MFN 09-101

Docket No. 52-010

March 27, 2009

Subject: **Response to Portion of NRC Request for Additional Information
Letter No. 296 Related to ESBWR Design Certification Application
– Electrical Power - RAI Numbers 8.1-20, 8.1-21, 8.2-15, and 8.2-16**

Figure 8.1-1. Electrical Power Distribution System

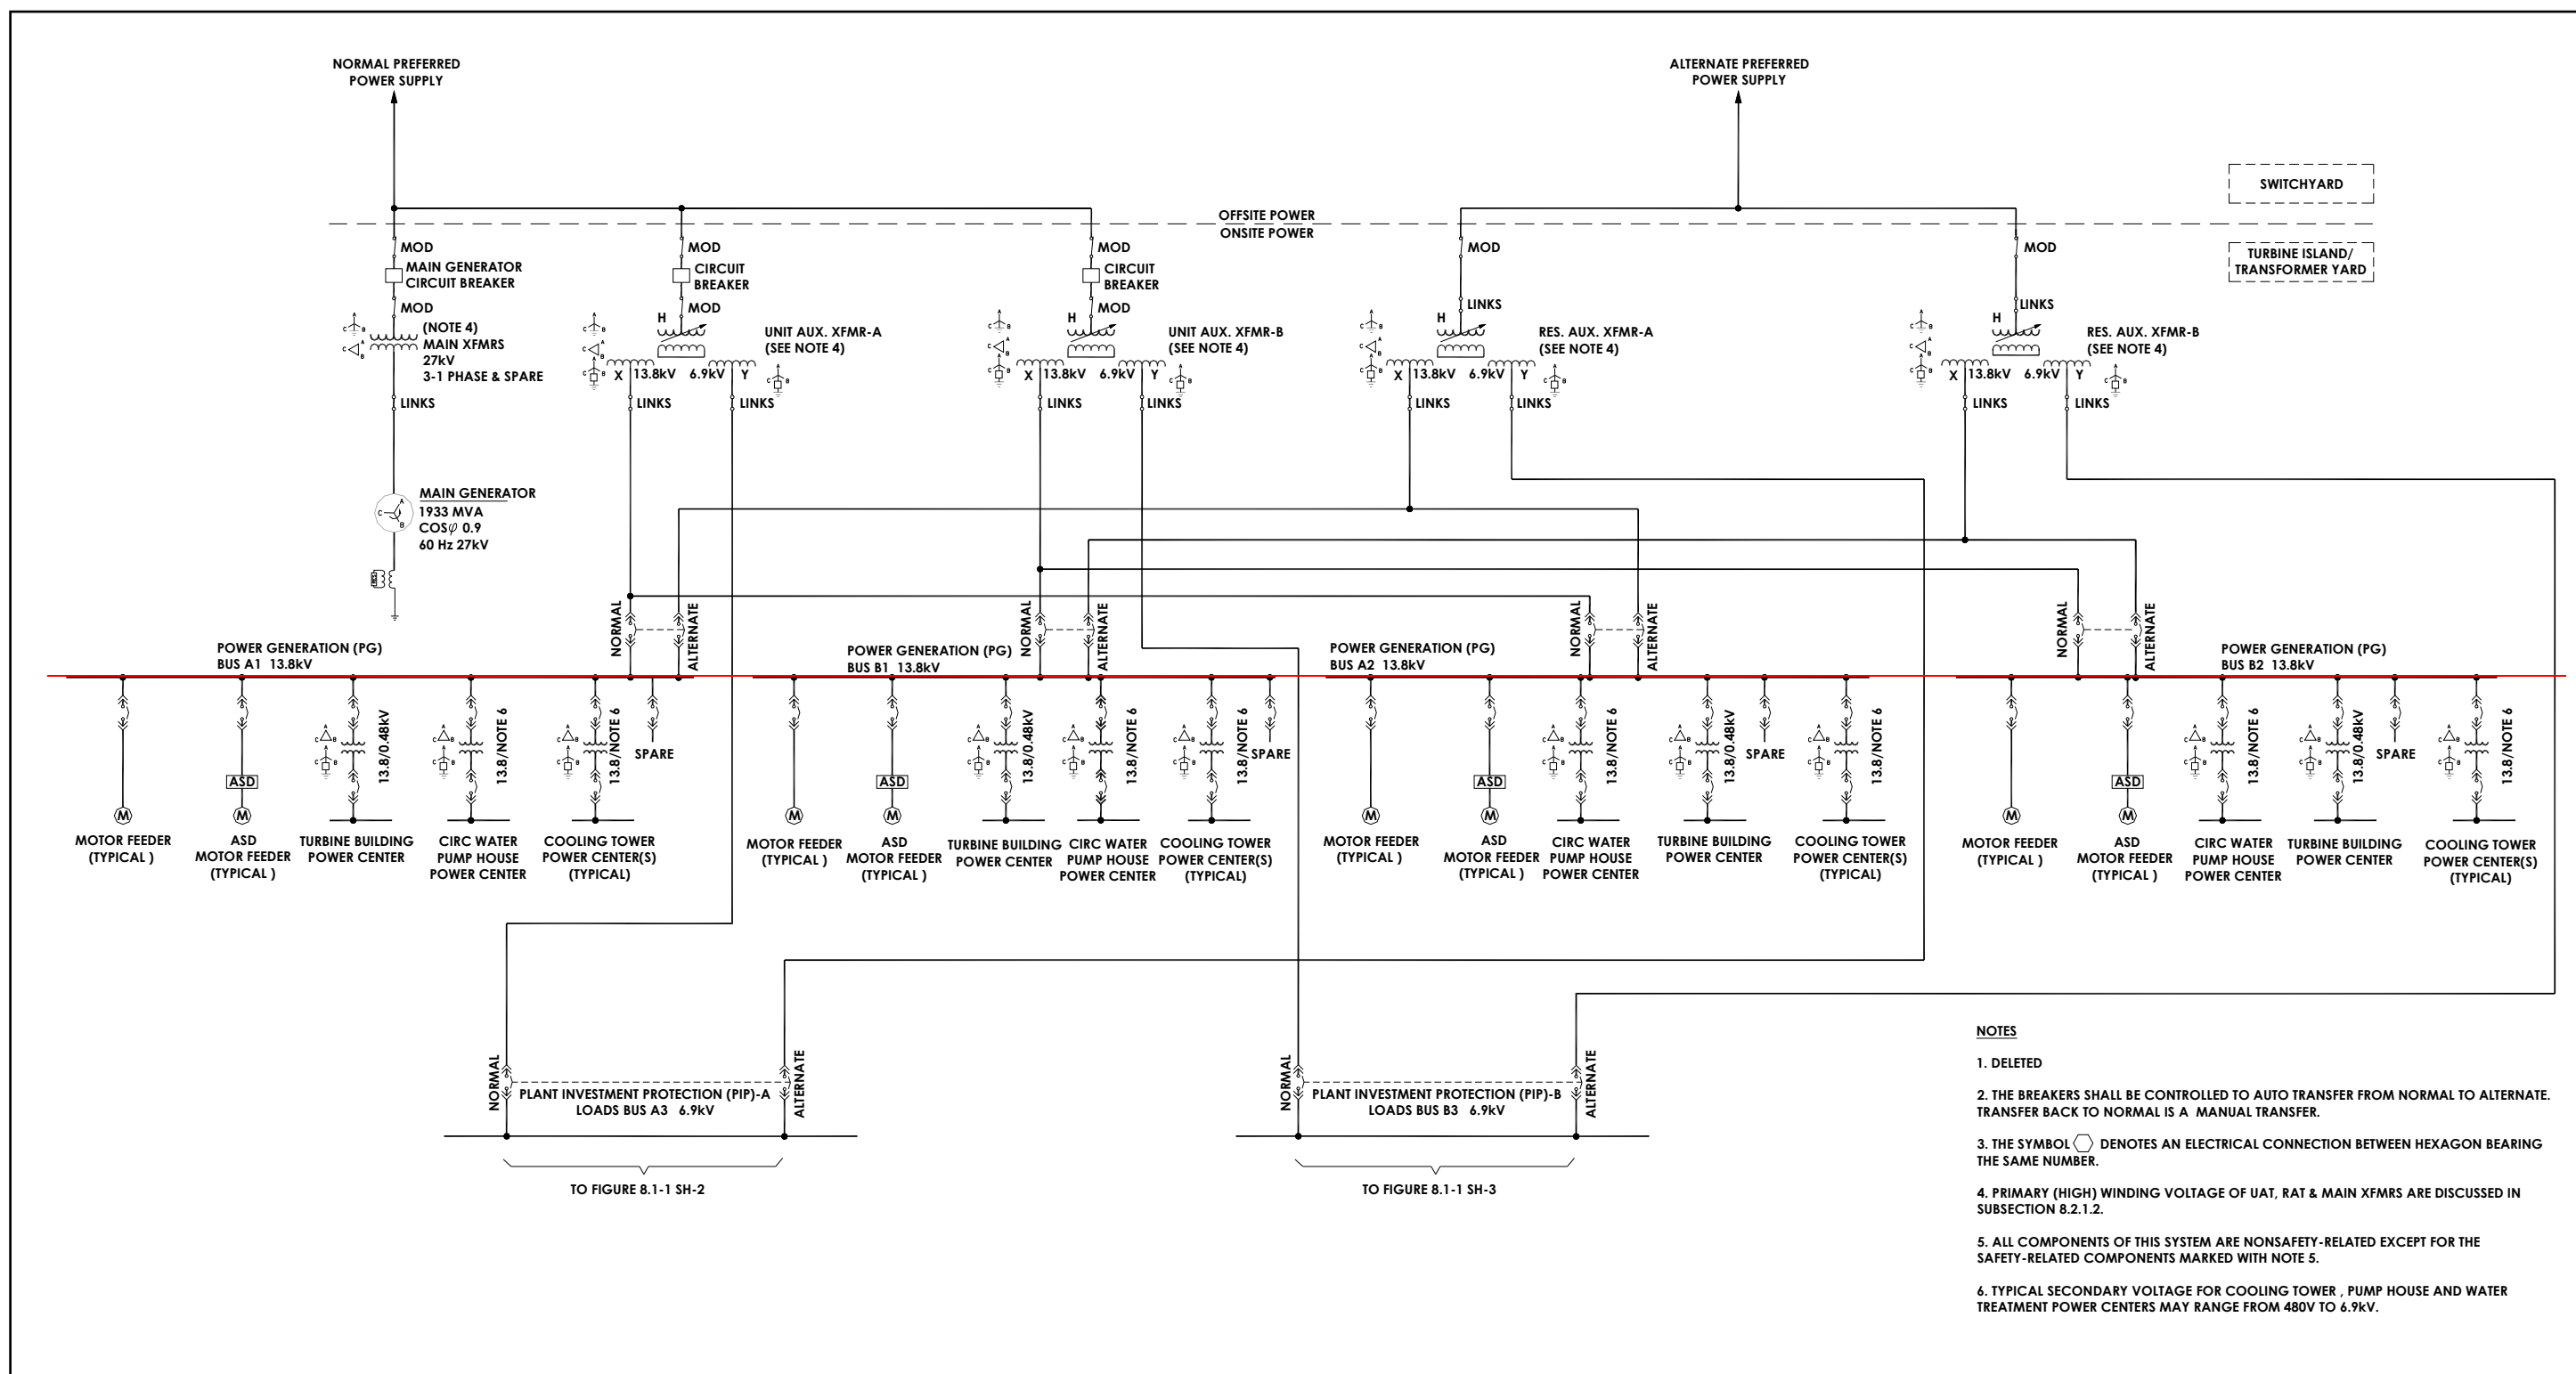
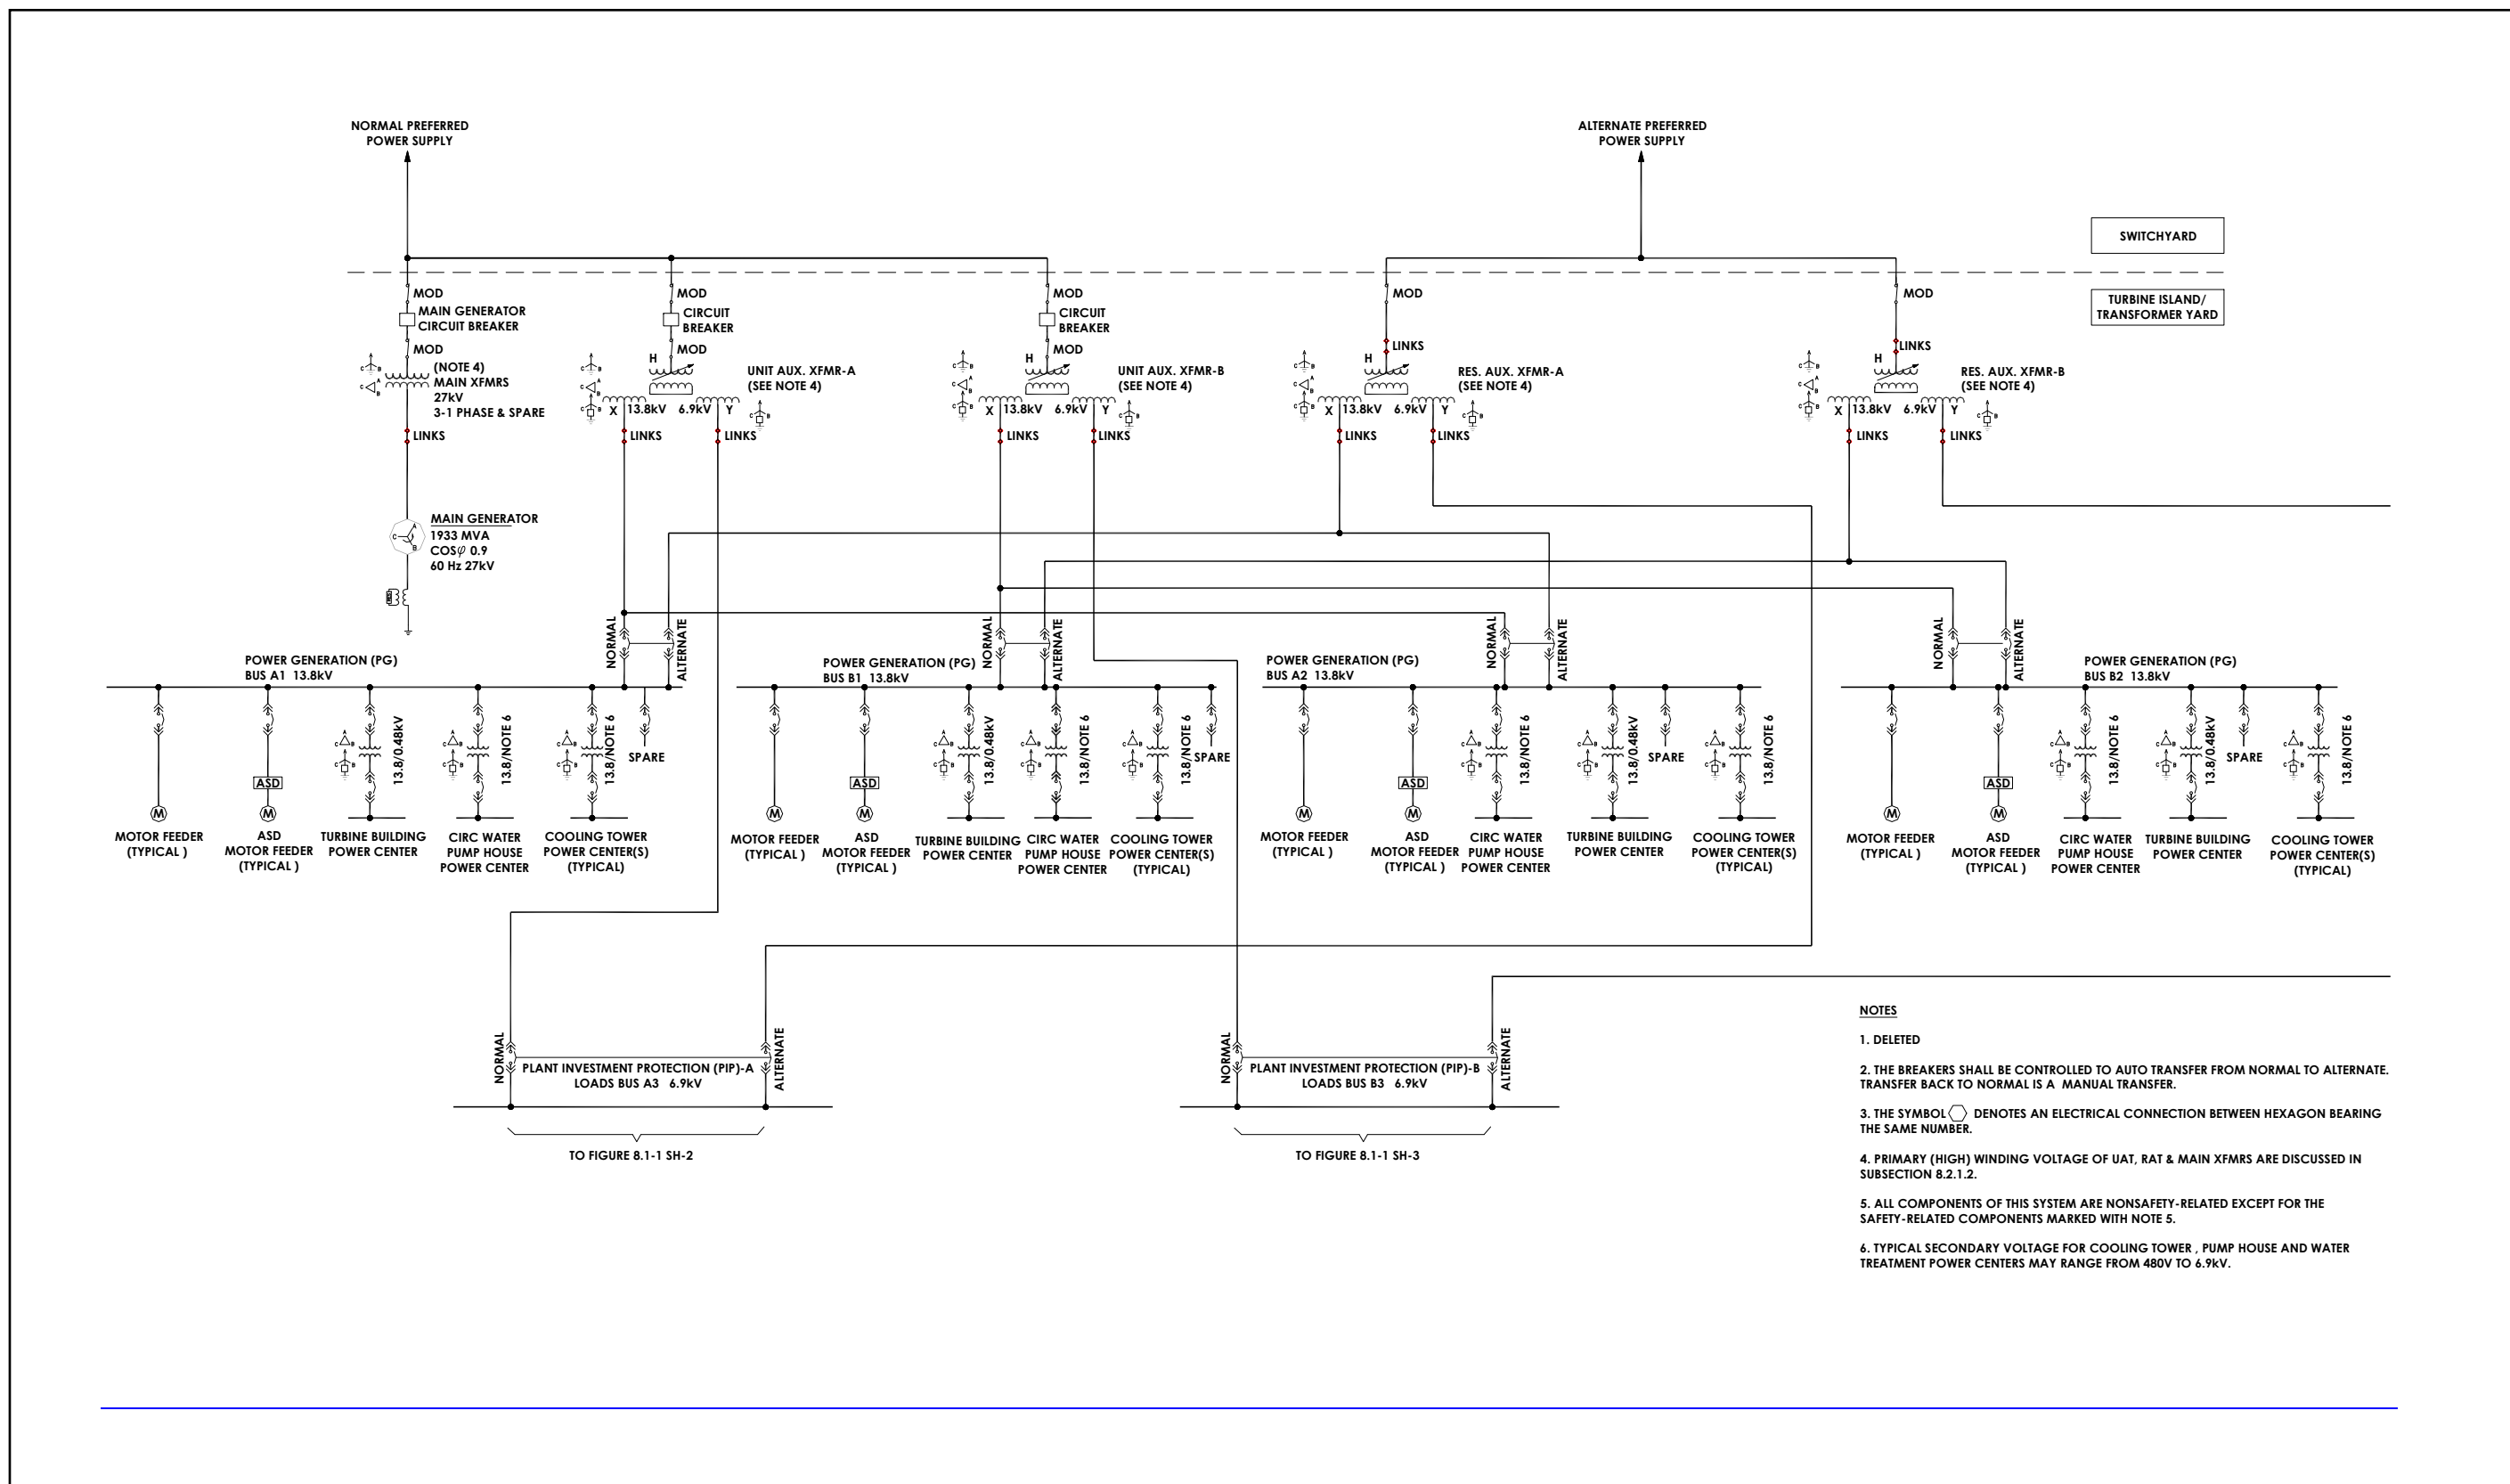
The response to NRC RAI 14.3-394 S01 states that the ESBWR design complies with GDC 17 and the preferred power supply definition per IEEE 765. In addition, DCD Tier 2, Table 1.9-22 states that IEEE 765 is applicable to the ESBWR design. However, DCD Tier 1, Figure 8.1-1, "Electrical Power Distribution System " incorrectly identifies offsite and onsite power boundaries. Clarify the offsite and onsite power boundaries by revising Figure 8.1-1 and DCD Tier 2, Section 8 to be consistent with GDC 17, IEEE 765 and SRP 8.2. Also, modify Tier 1 Section 2.13 as necessary.

To avoid future confusion, GEH will remove "Onsite Power" and "Offsite Power" from the existing boundary shown on DCD Tier 2, Figure 8.1-1 and DCD Tier 1, Figure 2.13.1-1. The boundary will remain in the location presently shown, but will be marked to read only "Switchyard" and "Turbine Island/Transformer Yard."

DCD Tier 2, Figure 8.1-1 and DCD Tier 1, Figure 2.13.1-1 will be revised in Revision 6 as noted in the attached markup.
